Re: S/D 90-48 - (Final Plat) Cedar Meadows Addition

At the regular meeting of the Subdivision Committee of the Metropolitan Area Planning Commission on Thursday, August 9, 1990, the above captioned plat was considered. The action of the Committee was to recommend that this plat be approved subject to:

CEDAR MEADOWS ADDITION

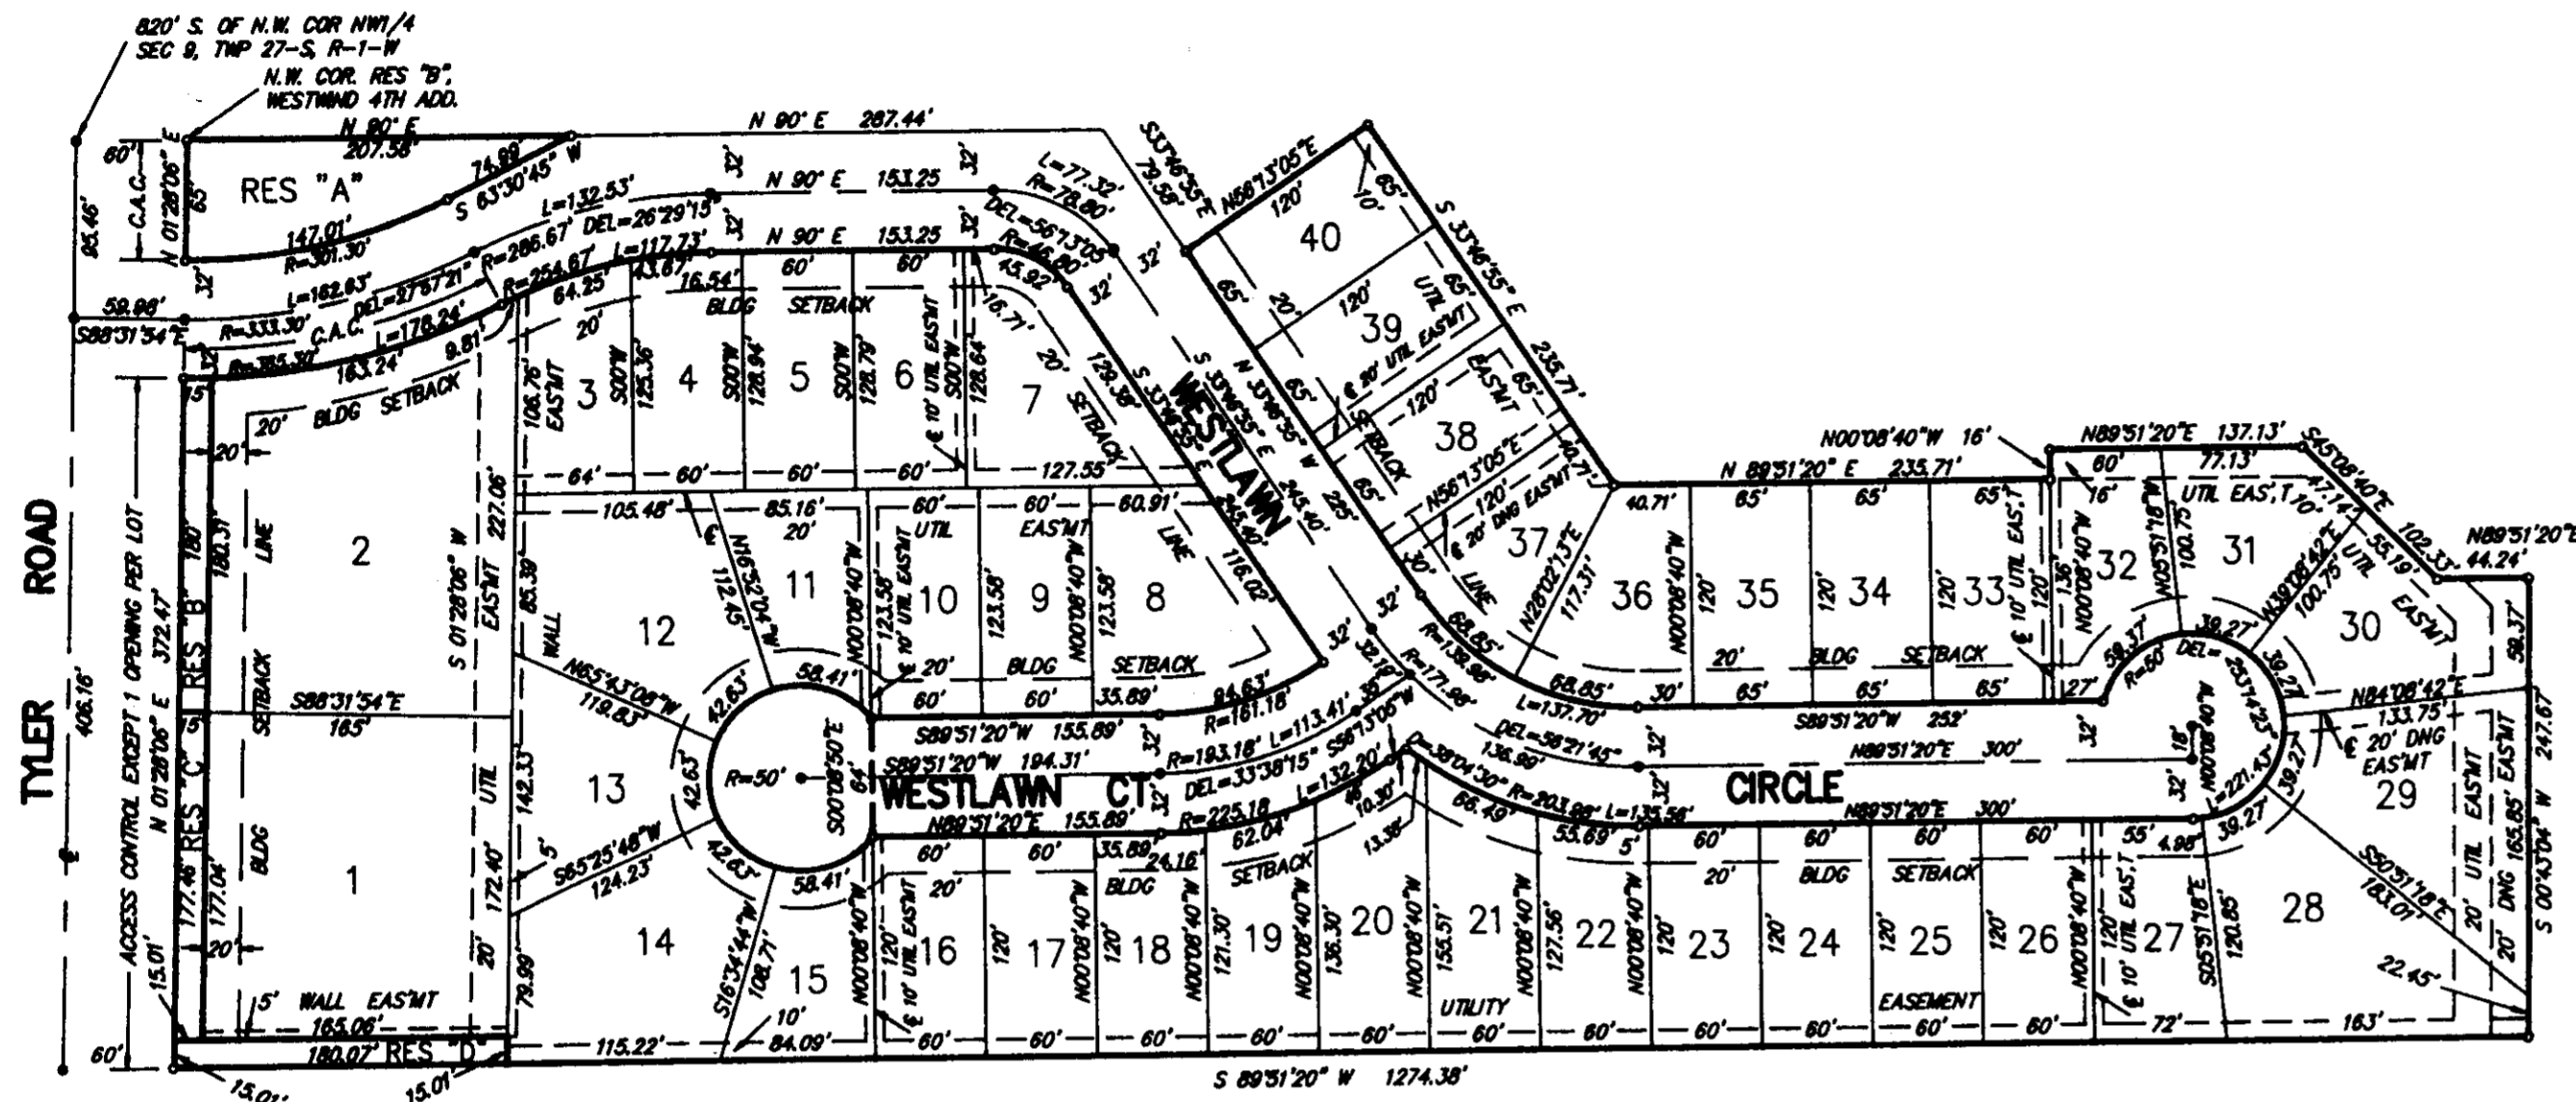
On the final plat, as indicated in the CUP for 64-foot street rights-of-way, 25-foot building setbacks shall be indicated as the front yard setback for all residential lots.

On the face of the plat and in the plattor's text, it shall be indicated if the minimum building pad elevations refer to the minimum floor or opening level.

On the final plat tracing, the following revisions shall be made to the plattor's text:

~~Line 3 shall be revised to indicate "platted into Lots, Reserves and streets. . ."~~

~~The reference to the Westlawn Court Cul-De-Sac being dedicated, noted in the lower section of the text should accordingly be deleted and replaced with the standard reference of "The streets are hereby dedicated to and for the use of the public."~~

~~On line five, the word reserved has been repeated and needs to be corrected.~~

~~Reserve D shall also be indicated as intended for "the preservation of the existing row of trees."~~

~~In regard to the location of openings being allowed in the areas of access control it shall be indicated that the City Engineer is to approve the location of any such openings.~~

~~I. As requested by KG&E, the final plat tracing shall indicate a 10-foot utility easement along Lot 30 and 30's common lot line and between Reserve B & C's and Lots 1 and 2's common lot lines.~~
